Northern Corridor Improvements Contract CA4239

S181(3) Alteration to Designation Rosedale Area

Notice of Alteration to Designation under Section 181(3) of the Resource Management Act 1991 (RMA)

TITLE	BUSWAY BRIDGE PERSPECTIVE 1		
DRAWING No	NCI-B-9067-DG-OLD-5192		REV
			B

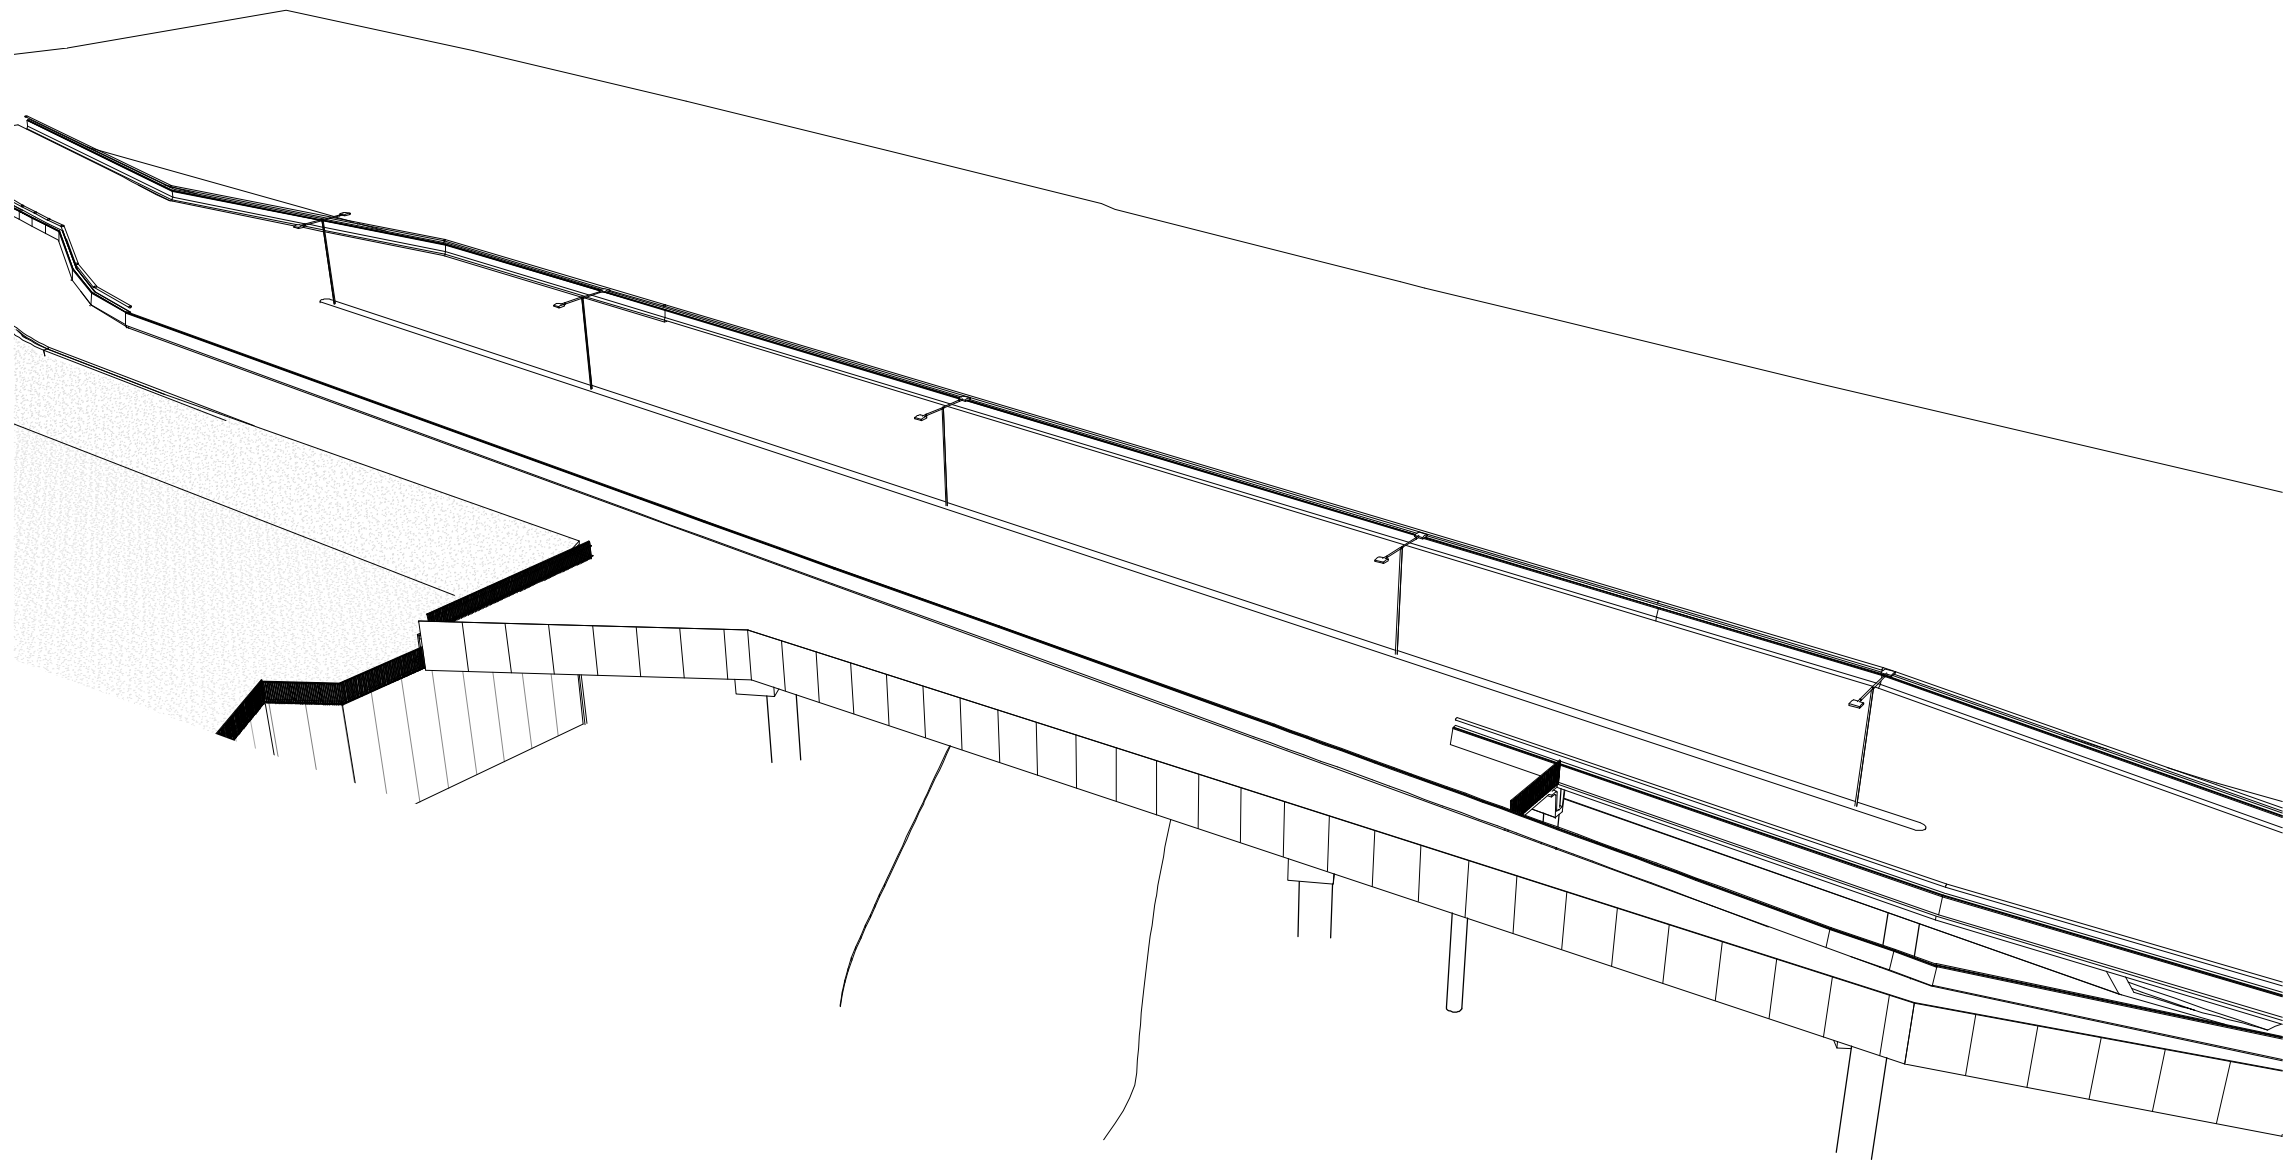
- 3.1 The variation will increase the width of the busway/SUP bridge for people on Rosedale Road, off-set by the removal of the SUP ramp structure. The area will retain similar characteristics and qualities.
- 3.2 There will be little difference for motorway users. While the busway and SUP will be widened at this location, the essential character of the corridor will remain unchanged.

- **13 Arrenway Drive:** This property is owned by NZTA and currently contains live-work units. The variation will not directly affect this property, but the increased width of the busway and SUP will be visible from the upstairs floors of the units, beyond the intervening property. The character of the outlook will remain similar to the approved NCI. Any change in visual effects will be ‘low’.

Figure 1: Noise contours from vibratory pile driving, calculated from actual noise measurements of the same activity from the NCI project.

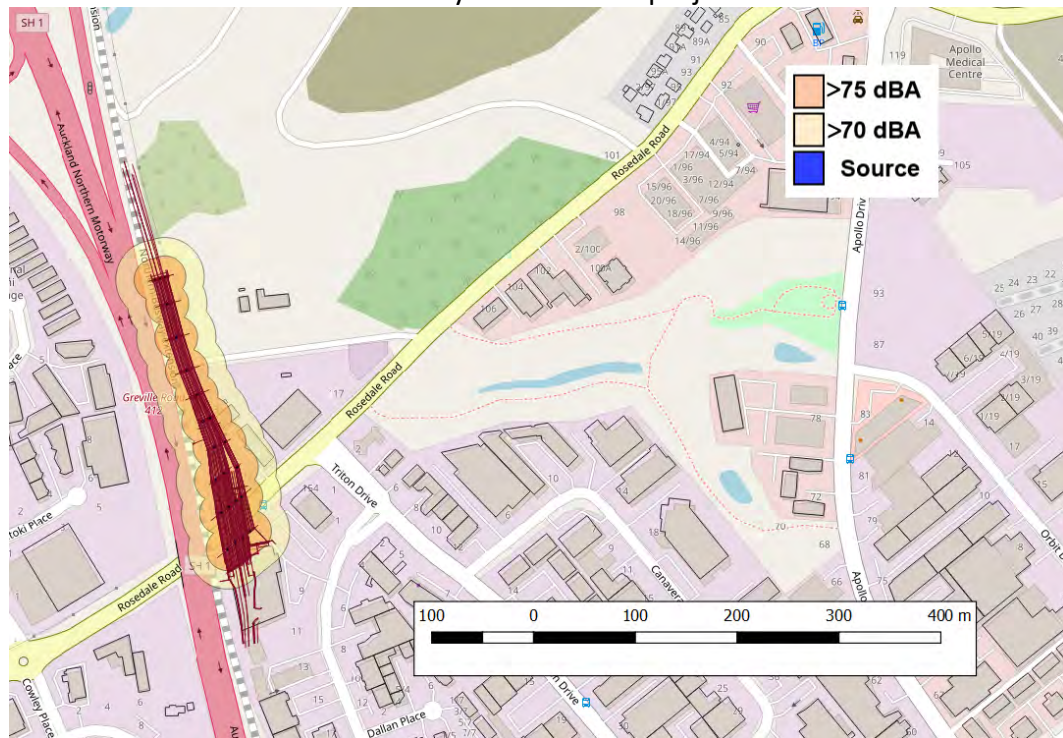
- 8 The level of effect from noise of vibratory driving of pile casings is less than predicted in the CNVMP (refer Figure C3 of the CNVMP). It should also be noted that the modelling does not predict any exceedance of the designation condition noise limits for vibratory driving of pile casings.

Figure 3: Vibratory pile driving predicted vibration contours for the alteration

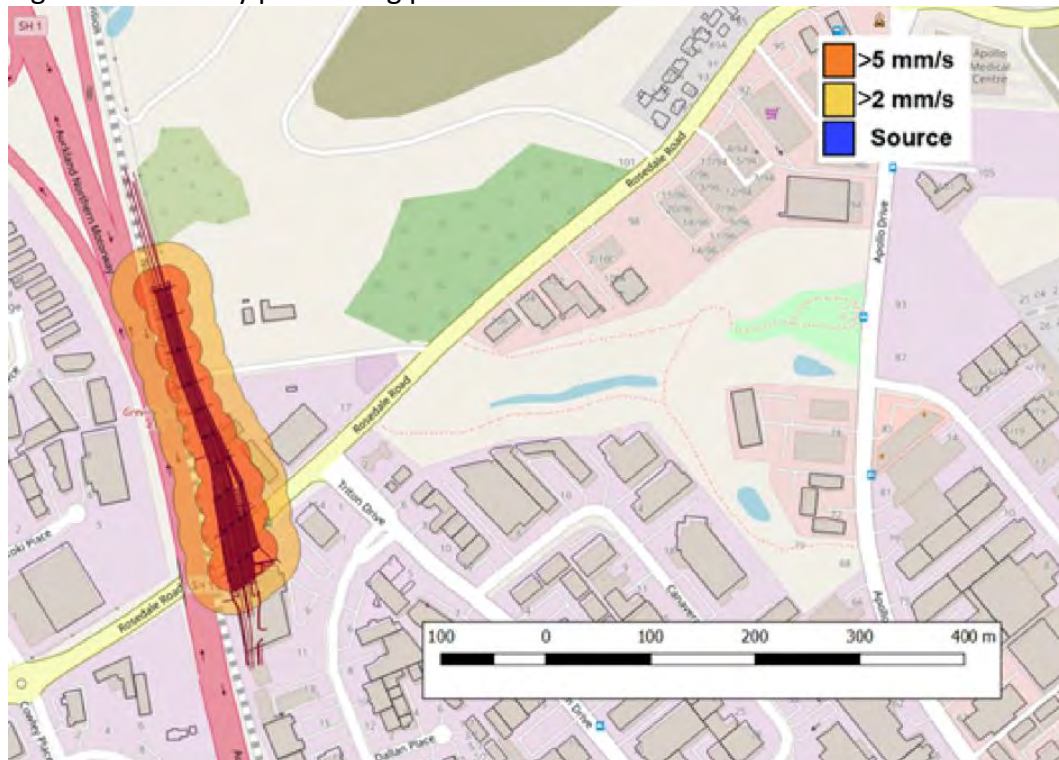
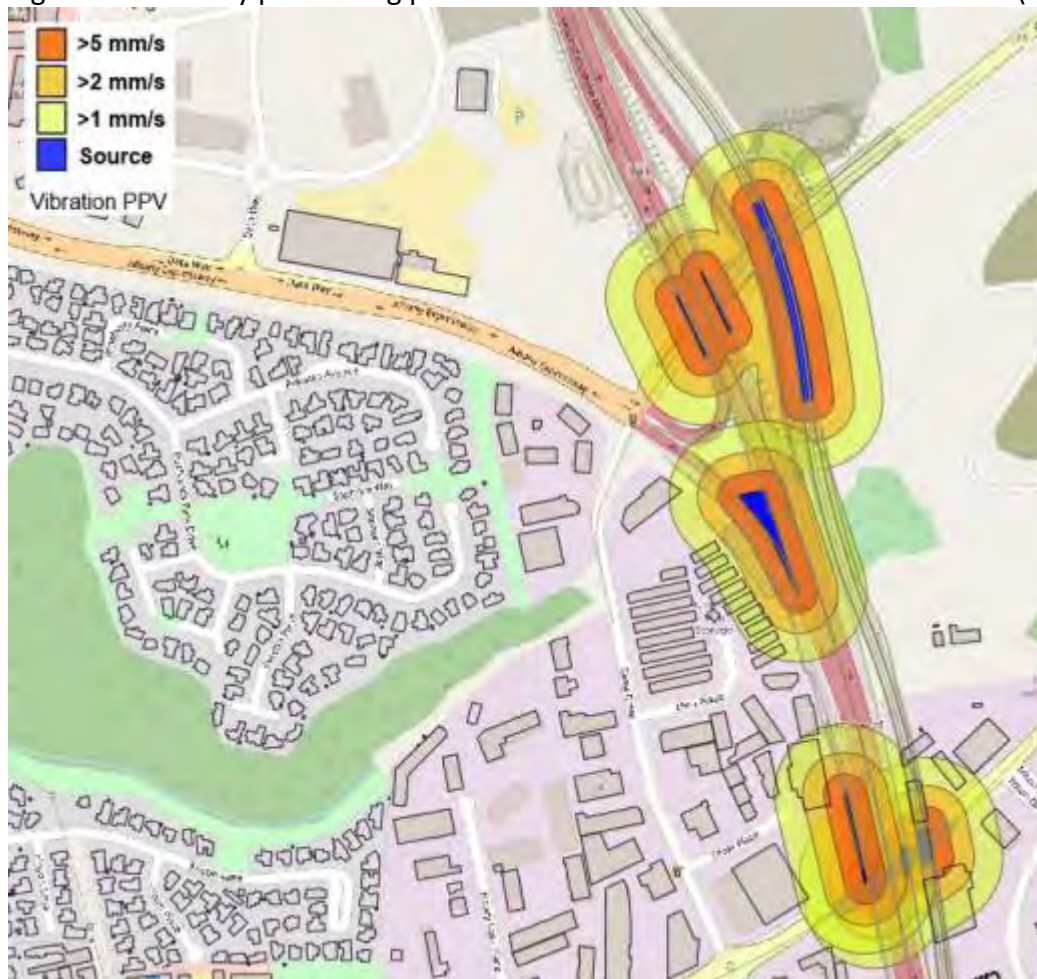
- 10 The predicted level of effect from the vibratory driving differs slightly from the than that predicted in the CNVMP (refer data used for Figure C4 from the CNVMP below). However, vibration levels will be monitored at piling locations furthest from nearby receivers initially with a SSCVMP prepared and mitigation (screw in pile casings) provided if required. Therefore, any change in vibration effects will be no more than minor.

Figure 5: Noise contours for placement and compaction of fill for the alteration

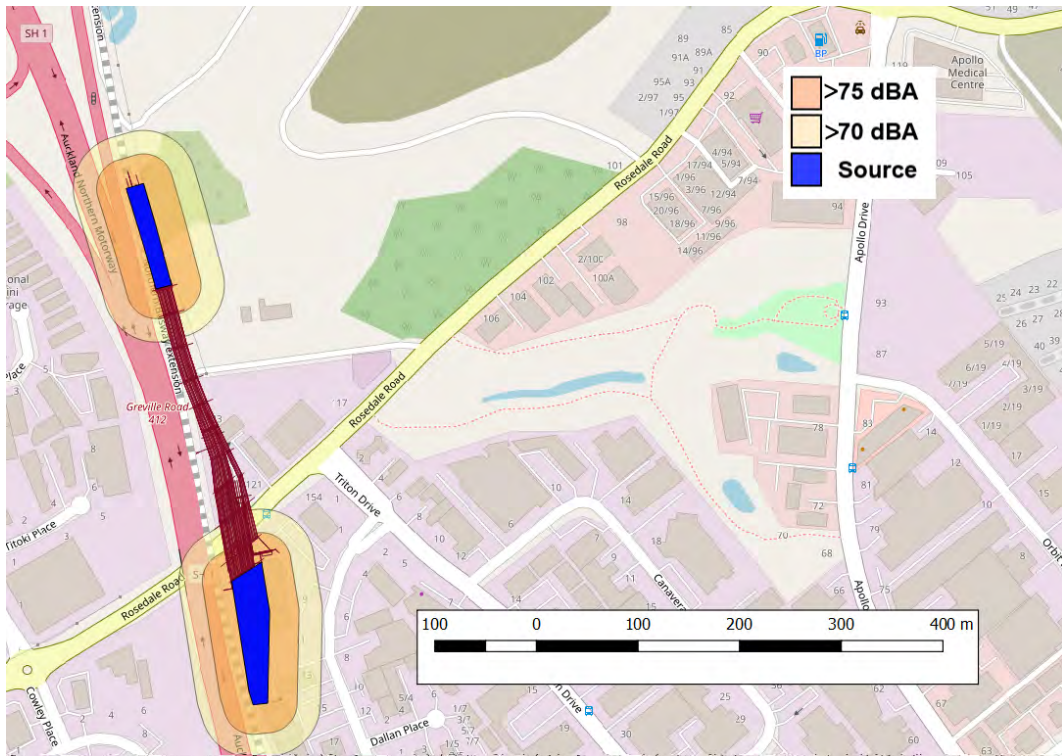
- 12 Vibration contours from fill placement and compaction have been calculated and shown below. The more detailed location of the fill placement and compaction works have led to less effects than those considered in the CNVMP (Figure C14). These works are not expected to require a SSCVMP.
